From: Sara Roediger, AICP
 Date: 3/30/2017
 Re: **2020 Gas Station Redevelopment
 Preliminary/Final Site Plan - Planning Review #2**

JRB
From: Jason Boughton, AC, Engineering Utilities Coordinator
To: Sara Roediger, AICP, Planning and Development Director
Date: March 30, 2017
Re: 2020 S. Rochester Road Gas Station, City File #99-028.3, Section 27
Site Plan Review #2

From: Michael Taunt, Survey Technician
To: Sara Roediger, AICP, Manager of Planning
Date: March 3, 2017
Re: 2020 South Rochester Road Gas Station
City File #99-028.3, Section 27
New Site Plan

CITY OF ROCHESTER HILLS
STANDARD DETAIL FOR:
Sight Distance Roadways

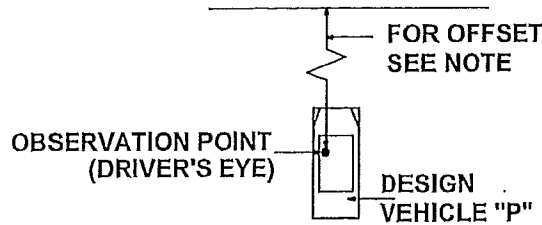
1. Finalize driveway approach design with MDOT.
2. On sheet L-1.0 and C-8.0, the roadway sight distance lines are intended for the vehicles exiting at the drive approaches.

CITY OF ROCHESTER HILLS
STANDARD DETAIL FOR:
Sight Distance
Pathways

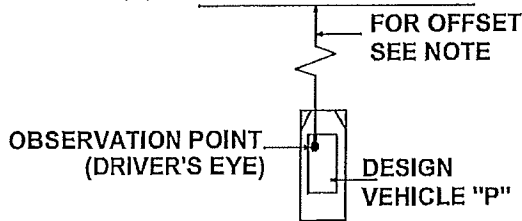
1. On sheet L-1.0 and C-8.0, the pathway sight distance lines are intended for the vehicles exiting at the drive approaches.
